SUBJECT: Initial Draft of Performance Specification Sheet MIL-PRF-19500/790am1,
Project Number 5961-2026-086.

INCH-POUND
MIL-PRF-19500/790
w/AMENDMENT 1
DRAFT
MIL-PRF-19500/790
12 May 2023

TRANSISTOR, FIELD EFFECT RADIATION HARDENED, N-CHANNEL,
SILICON, TYPES 2N7655, 2N7656, 2N7657, QUALITY LEVELS JANTXV AND JANS

* FIGURE 1. Dimensions and confi

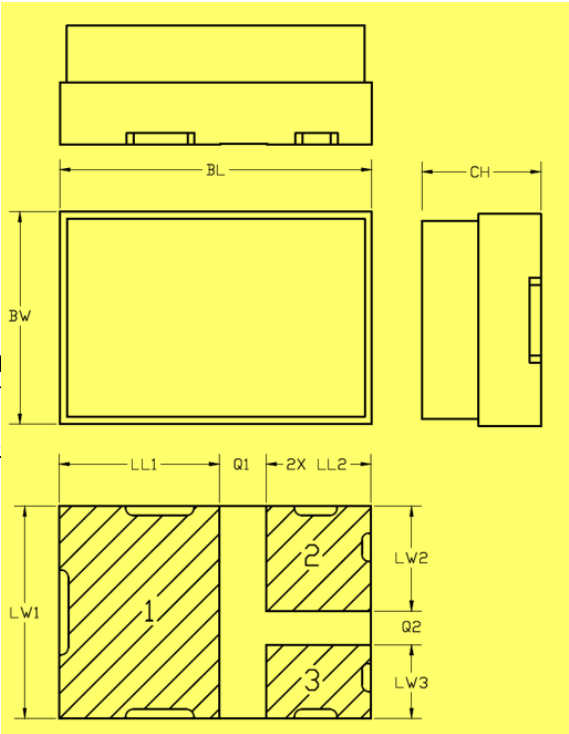
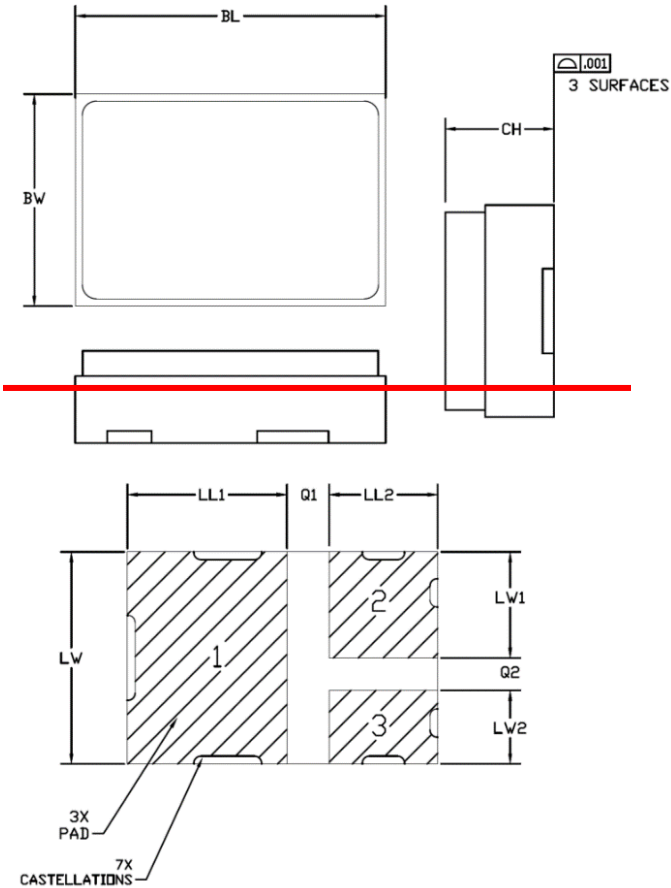
The initial draft of the subject document was generated to update the case outline and characterization data and to update it to the latest document format and various editorial changes to bring it into compliance with MIL-STD-961. Highlighting has been used for easy change recognition.

Ltr	Dimensions			
	In	In	mm	mm
	Min	Max	Min	Max
BL	.215	.225	5.46	5.72
BW	.145	.155	3.68	3.94
CH		.077 .101		1.96
LW1	.142 .145	.158 .155	3.64 3.68	4.04 3.94
LW12	.070 .069	.080 .079	1.78 1.75	2.03 2.01
LW23	.047	.057	1.19	1.45
LL1	.108	.118	2.74	3.00
LL2	.072 .069	.082 .079	1.83 1.75	2.08 2.01
Q1	.033 .030		0.84 0.76	
Q2	.022		.56
